Address: 5024 Rainier Ave S, Seattle WA 98118 Owner: Duong Kiem Hung & Xuanthi Le Parcel No.: 564960-0120 Lot Size: 4401

### Aerial View of Proposed Covered Area

# Corrections Requested on 10/10/2024 LPB 279/24 Record # DONH-COA-01469

#### Front View

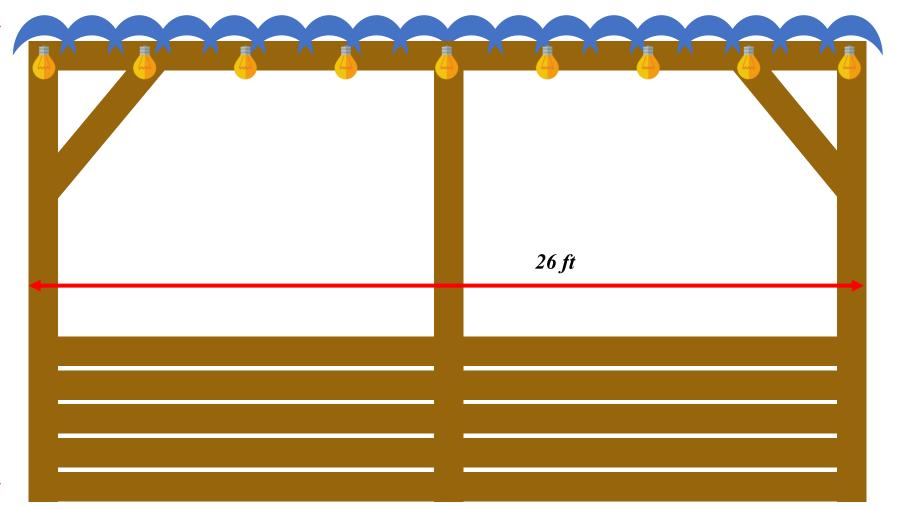
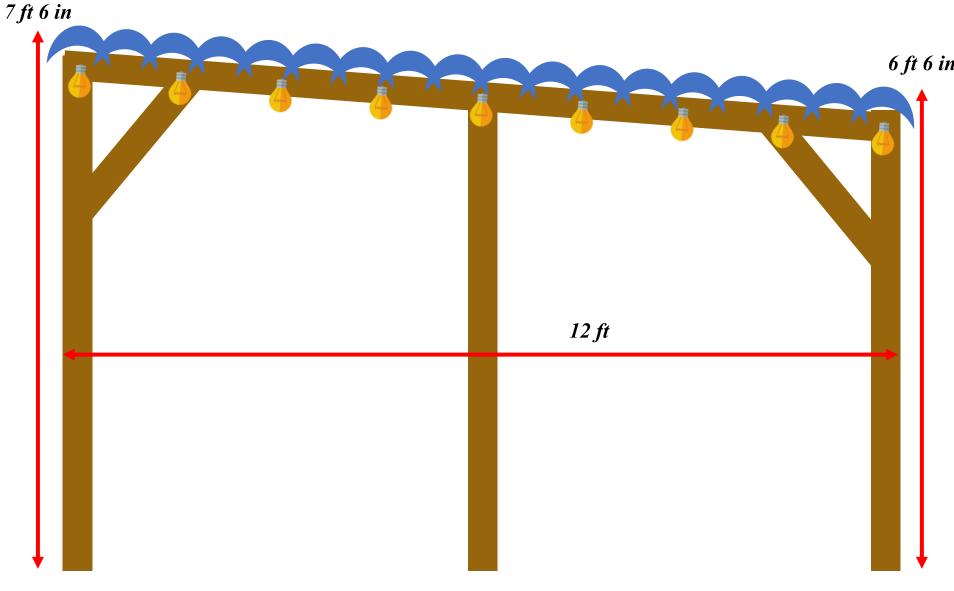
- 1. Please confirm if there will be horizontal panels/slats on the shorter sides of the structure.
  - There will be no horizontal panels / slats on the shorter sides of the structure as (i) one will be an entry way for customers, and (ii) the other on the East side of the structure will be close to the perimeter fence. There will be diagonal supports at the top to provide additional stability (as shown in images in previous pages).
- 2. Confirm footing or method of attachment, for stabilization.

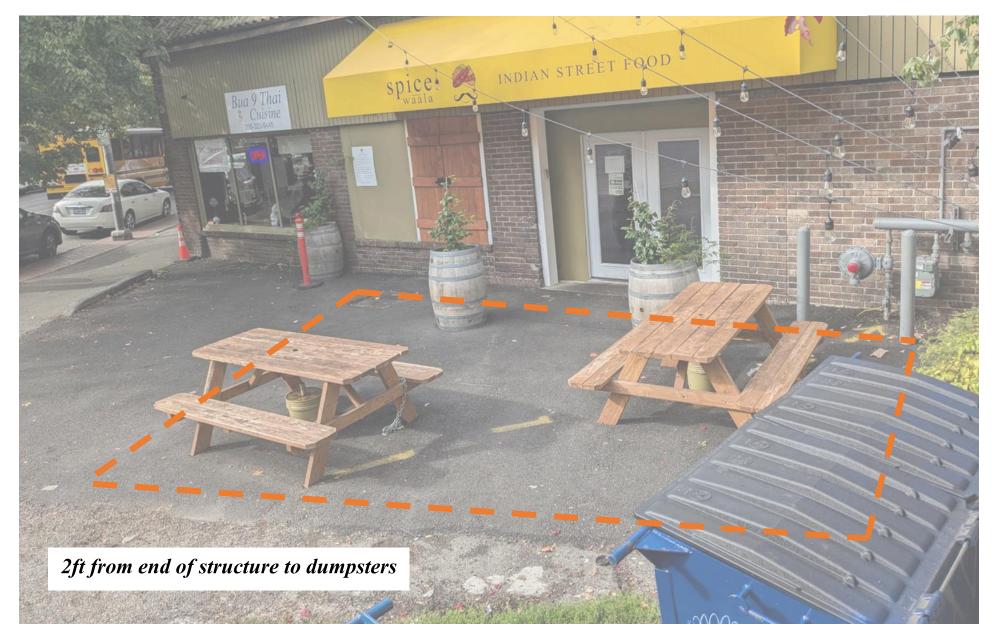
3. Cut sheet, specifications or photos for the lighting fixtures. Are they identical to those that are currently suspended? Will those remain once the structure is in place?

The existing lights will be extended (identical fixtures used) to wrap around the exterior of the new structure. Therefore, there will be lighting above the existing structure and on the outside edges of it and the existing pattern will remain the same.
